**MODIFICATION REQUEST:
Nepean Health Precinct - Mixed Use
Development**

- **Concept Plan Modification
(MP09_0197 MOD 1)**
- **Stage 1 Project Modification
(MP09_0220 MOD 1)**

Director-General's
Environmental Assessment Report
Section 75W of the
Environmental Planning and Assessment Act 1979

April 2013

Figure 5: North east corner of proposed modified development

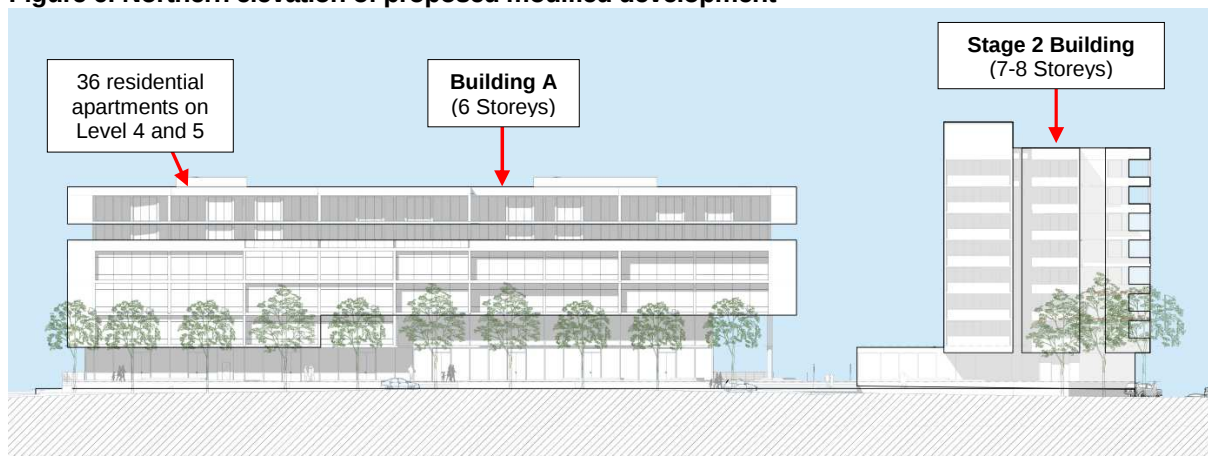
A breakdown comparison of the approved and proposed modified concept plan and Stage 1 and 2 GFA, landuse and car parking figures is provided in Table 1. Additionally, the proposed modified development, as viewed from the north-east corner, is provided in Figure 5, and the proposed modified northern elevation of the development is shown in Figure 6.

The proposed modification includes the removal of the top storey (Level 6) of Building A, and replacing commercial Levels 4 and 5 with 36 residential apartments. The removal of the top storey results in a reduction in building height of 7.3 m (from RL 86.4 to RL 79.1). Additionally, the modification includes replacing retail floor space on Lower Ground Level with car parking, and replacing commercial floor space on the Ground Level with retail floor space.

The reduction in height will result in a reduction in overshadowing of the adjoining Nepean Private Hospital from the approved development, and will further emphasise the larger Stage 2 'marker' building (located at the corner of The Great Western Highway and Parker Street). The residential apartments on the upper two levels of Building A are also setback from the northern edge of the building facade (fronting the Great Western Highway) and will result in a slight change in the appearance of the building through the addition of residential balconies and fenestrations on the upper floors. However, the overall bulk and scale of the building will remain relatively unchanged, and the building will continue to present as a predominantly commercial building with horizontal expression addressing the Great Western Highway.

The department considers that the key change in built form of the development is the reduction in height and in introduction of residential apartments to the upper floors of Building A. Whilst the appearance of the building will be slightly altered on the upper residential levels, it will continue to present as a predominantly commercial building fronting the Great Western Highway. Given the department was satisfied with the bulk and scale of the approved development, and the proposed modified development results in a minor reduction in overall bulk and scale when compared to the approved development (particularly for Building A), which results in a reduction in overshadowing impacts to the adjoining Nepean Private Hospital when compared to the approved development, the department is supportive of the proposed modifications.
